COUNCIL ACTION FORM

SUBJECT: REZONE AND MAJOR SITE DEVELOPMENT PLAN FOR 125 AND 130 WILDER AVENUE PLANNED RESIDENTIAL DISTRICT

SUNSET RIDGE TOWNHOMES

Plant Schedule

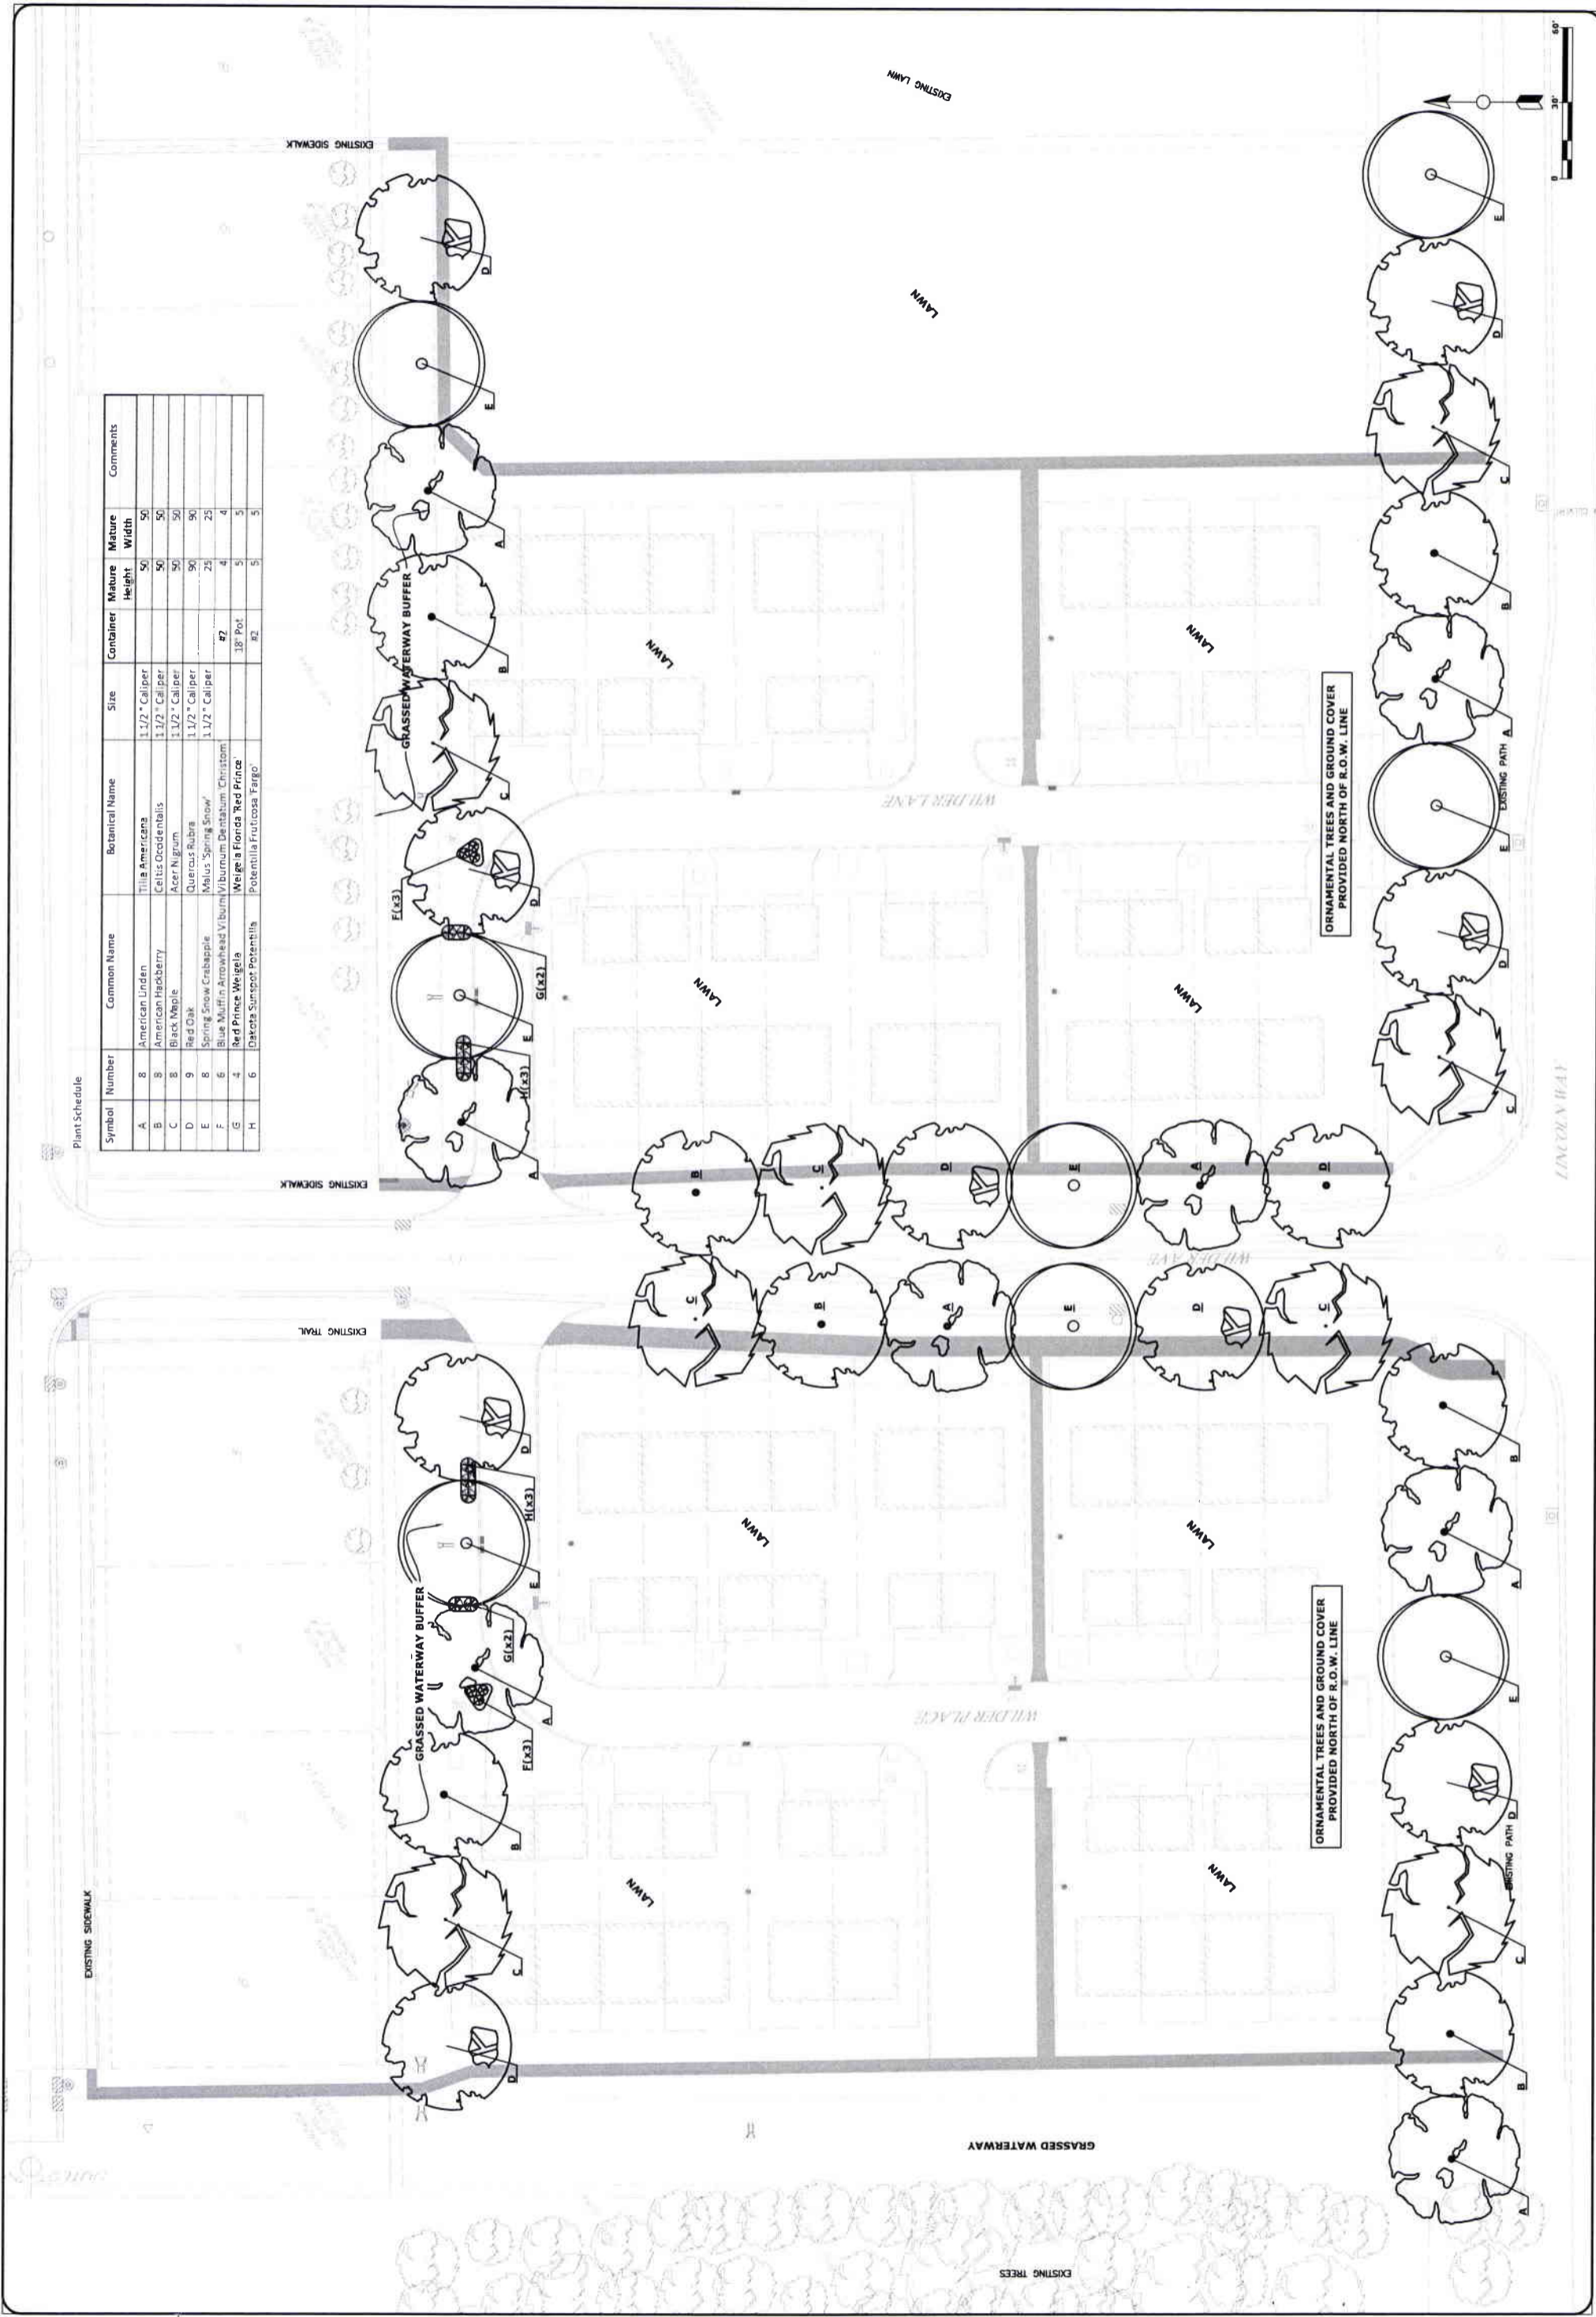
- ii. Revision of the landscape plan to include the clustering of additional shrubs along the north property lines to meet the intent of the L3 screen buffer for the PRD.

The L3 requirement (6-foot tall screen), includes the requirement for 1 landscape tree for every 50 lineal feet and shrubs spaced 6 feet on center or a fence. With a total lineal length of 748 feet of property line, this would require 14 trees as well as shrubs spaced at 6 feet on center. The applicant proposes a landscape design with the required number of trees, but relies upon the wider width of the buffer to mitigate the screening/fence requirement. Additionally, the applicant has proposed a small number of clusters of shrubs along the driveway, but has not included a substantial number of shrubs that are normally required in L3. **Staff supports the general design for the wider separation over the literal standards of L3 for the property line fence and screening. Staff does recommend adding some additional shrubs to diversify the landscaping mostly to be added along the area of the private drive.**

north side of the townhome development to help screen areas of the private street from the rear yards of the neighboring single family homes. The submitted plan indicates the trees required for the buffer but is very lacking in the amount of shrubs indicated on the plan from the minimum intended for this type of buffer. Staff would suggest a revision of the landscape plan to include the clustering of additional shrubs along the north property lines to meet the intent of the L3 screen buffer for the PRD.

Project Number: 15015
Date: 09/09/2015
Sheet Contents:
Building Elevations

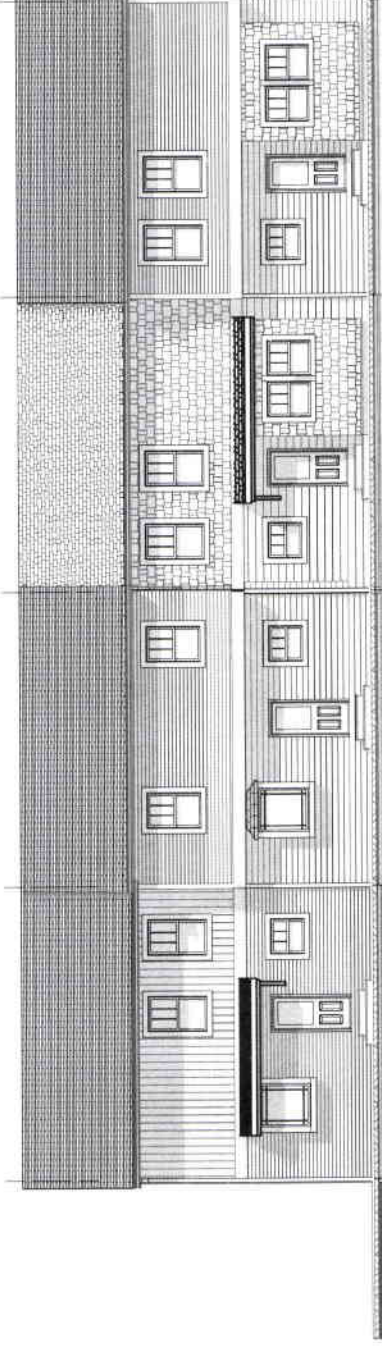
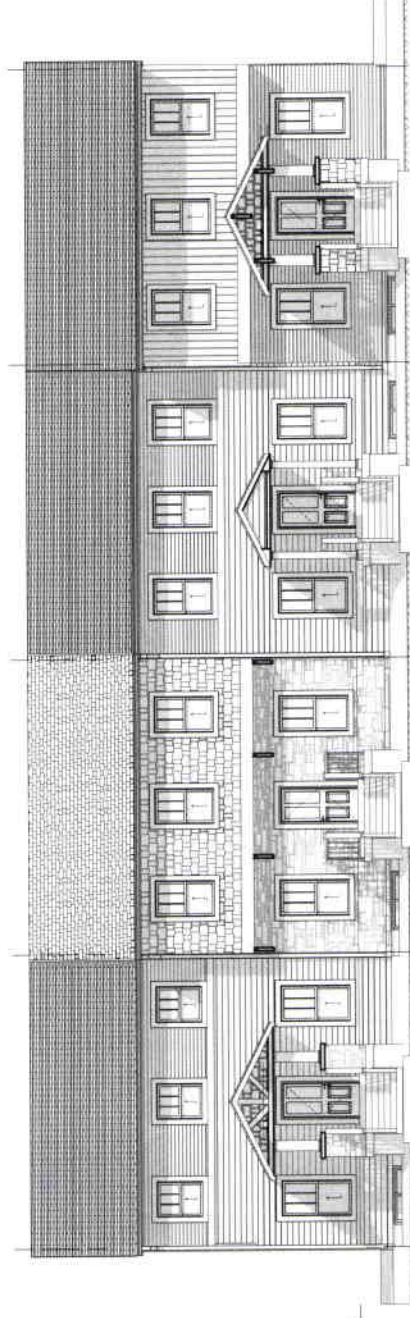
- iii. Final approval of the landscape plan details by staff.
 - iv. Add a stone or brick treatment to the foundation of the front façade of each building (approximately 150 square feet per unit).

- v. Add a front porch that extends across half of the front façade of one townhome unit for each building (total of 12 units).

The architectural design promotes unit identity and orientation to public spaces. This is a positive design approach that typically supports a walkable environment that relates to its surroundings and does isolate individual homes. The Plan provides parking spaces that exceed the minimum requirement of the zoning code. The overall organization and layout of the site is oriented to the address potential concerns of the surrounding neighborhood, with further development of the landscape buffer, and accommodates the required common open space requirements of the PRD. The connection to the existing sidewalk and trail system helps to incorporate this style of residential development with the existing single family homes of Sunset Ridge subdivision. As entry level housing, the project attempts to use common building materials to fulfill the desired character for the homes. It principles relies upon vinyl siding and some basic architectural features of covered entries and slight modulation in the roof line. Staff believes that adding a base material to the foundation will help to add character to the homes style.
